UNITED STATES PATENT AND TRADEMARK OFFICE

APPLICATION NO.	FILING DATE	FIRST NAMED INVENTOR	ATTORNEY DOCKET NO.	CONFIRMATION NO.
09/809,074	03/16/2001	Shinya Nagamatsu	204842US-8	5550

Office Action Summary

DETAILED ACTION

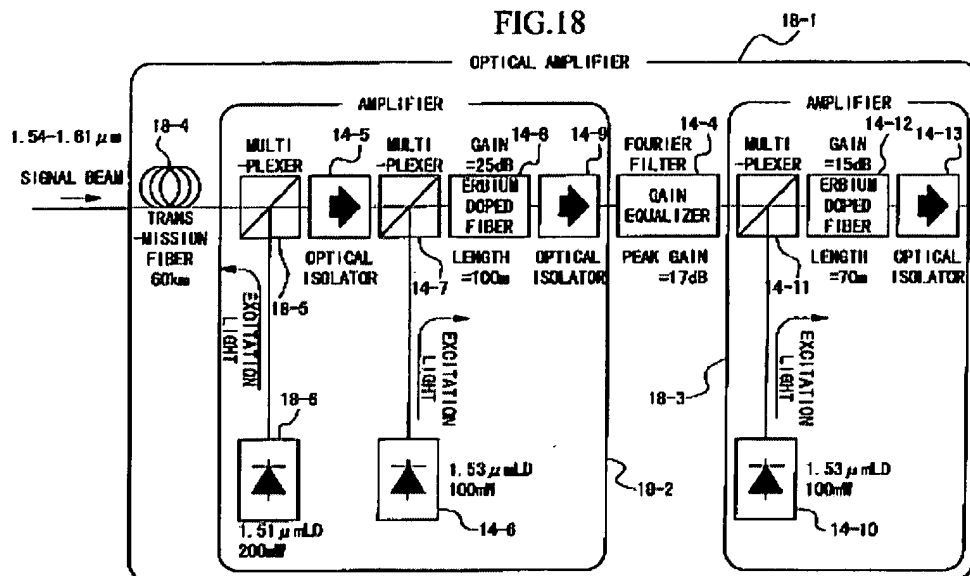
5. Claims 1 and 12 are rejected under 35 U.S.C. 102(b) as being anticipated by Scifres et al (4,820,010). Scifres et al discloses the claimed invention. Note figure 1 which illustrates an optical transmission system comprising a light source configured to produce an optical signal (25), the light source comprising a plurality of densely placed laser diode modules (11, 12, 13), each module (11, 12, 13) outputting at least 100 mW

(see col. 4 lines 20-54).
